HISTORIC LANDMARK COMMISSION

RONALD McDonald HOUSE
PLNHLC2011-00503
901 East South Temple
May 2, 2013

Request

EXTERIOR MATERIALS
 Ronald McDonald House - Phase 1
 CRSA, 2013-April-03

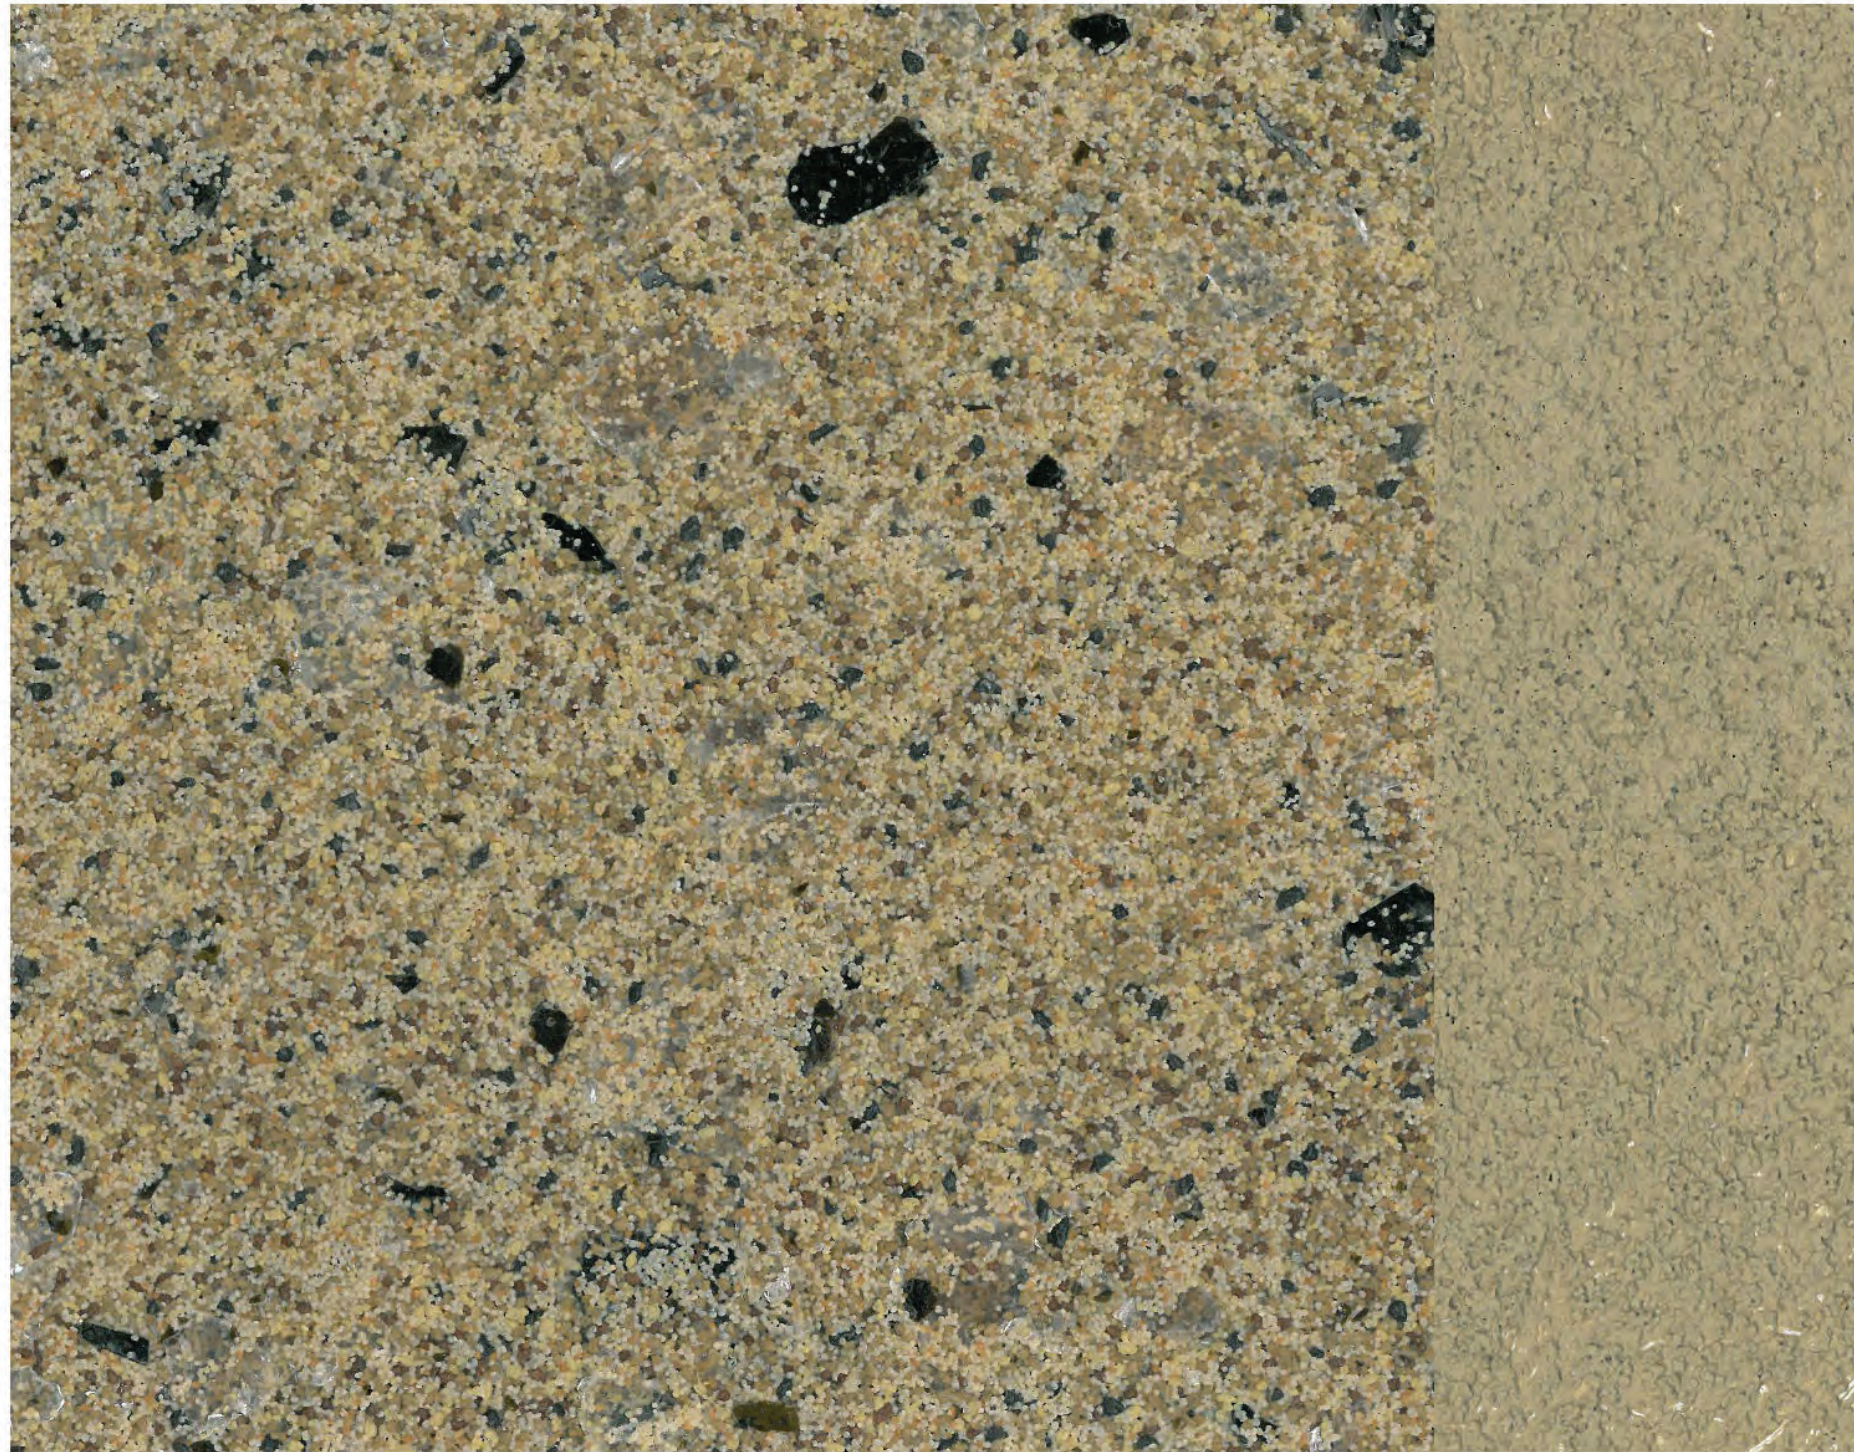
The attached, highlighted elevation diagrams show where brick and faux stone products will be installed on the subject project. Also attached are photographs of this product installed around the Salt Lake and Utah valleys which we observed to appear as faux stone. Observations of this or similar products on buildings constructed more than 15 years ago were noted as appearing to be the same quality as new installations, noting no visible degradation. This shows the product to be successful, long-lasting, and attractive after many years.

The TerraNeo installations we observed as most successfully representing stone were installed adjacent to another real material, i.e., real brick masonry or stone masonry. We believe this juxtaposition, along with care in detailing, will further enrich the visual attractiveness of the product. The RMH building will have installations of the TerraNeo product adjacent to brick at the vast majority of the transitions.
